**CITY OF DOVER, DELAWARE
PLANNING COMMISSION
Monday, October 21, 2024 at 7:00 PM**

- [3.](#) C-24-02 Luther Village IV: Planned Neighborhood Design – Senior Citizen Housing Option on Babb Drive – Update on Waiver Request for Elimination of Rear Emergency Access: The Planning Commission on September 16, 2024 granted conditional approval of the Conditional Use Site Plan/Master Plan for the development of Luther Village Planned Neighborhood Design – Senior Citizen Housing Option consisting of up to 524 age-restricted apartment units in a total of nine phases and including approval of a series of Alternative Design Standards, Waiver Requests, and recommended approval of Subdivision Waiver Requests. Action was deferred on the Waiver Request for the Elimination of Rear Emergency Access. The Master Plan was previously established by Applications C-02-02 and C-13-03 and Luther Village Phases I, II, and III have been constructed. The plan for Phase IV consists of the construction of a three-story apartment building with 72 units (age-restricted) and associated site improvements. The plan also includes a Minor Subdivision to create a 2.79 acre+/- parcel for Phase IV from the overall 33.63

PRELIMINARY
LANDSCAPE PLAN

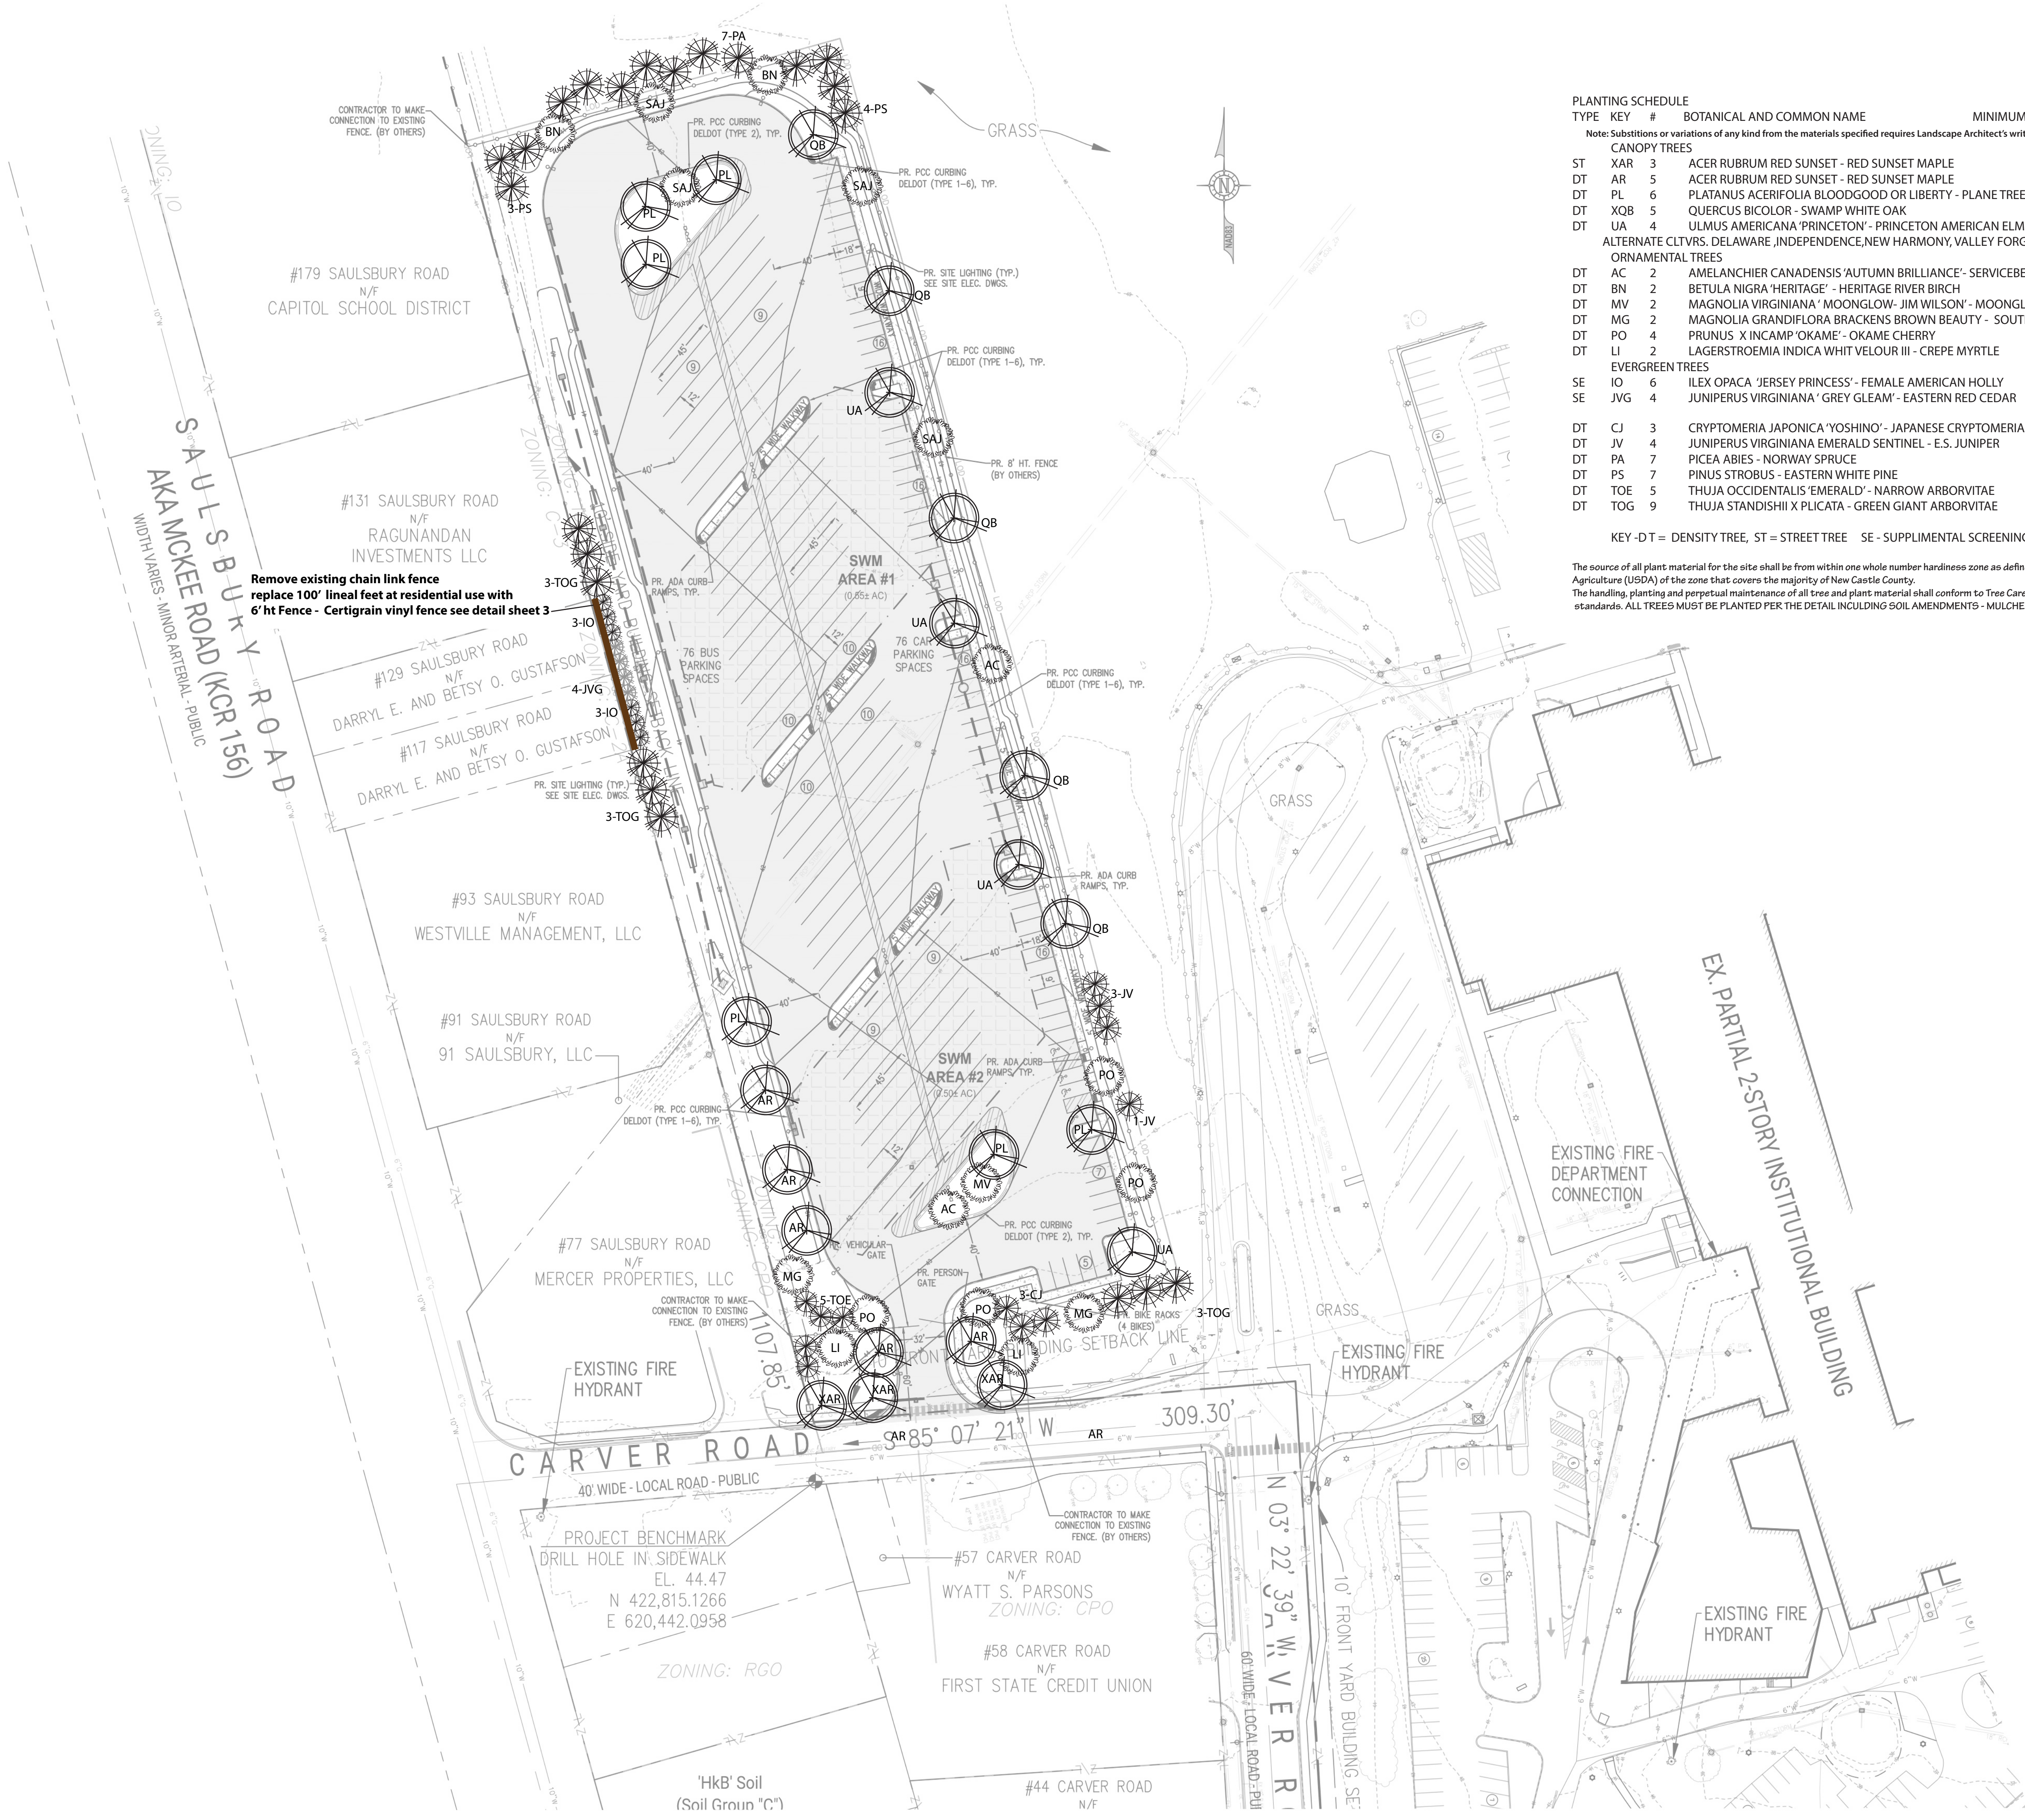
- 6) Sheet LP-1 - Landscape Plan and series:
 - a) For Supplemental Screening note, add reference: *Zoning Ordinance*, Article 5. Currently only the Section is given.

- b) Check Limit of Disturbance size. This is used as the Development Area for tree planting calculations, Update as necessary.
 - c) Sheet LP-02:
 - i) Identify any existing trees within the property area and their status.

- v) Confirm the height of the opaque barrier fence. In most places it is listed at 6 feet except for the details notes on Sheet LP-03 where style says 8 feet.
